Addendum No. 1

City of Coquitlam

Tender No. 72471

2021 Austin/Blue Mtn/Walker Pavement Rehabilitation

MANHOLE COVER & FRAME

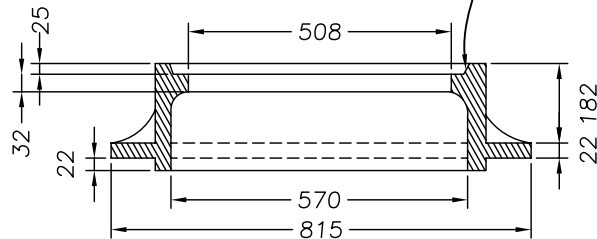
- a) **Add** Coquitlam Detailed Drawing **COQ-S16** (Manhole Cover & Frame).
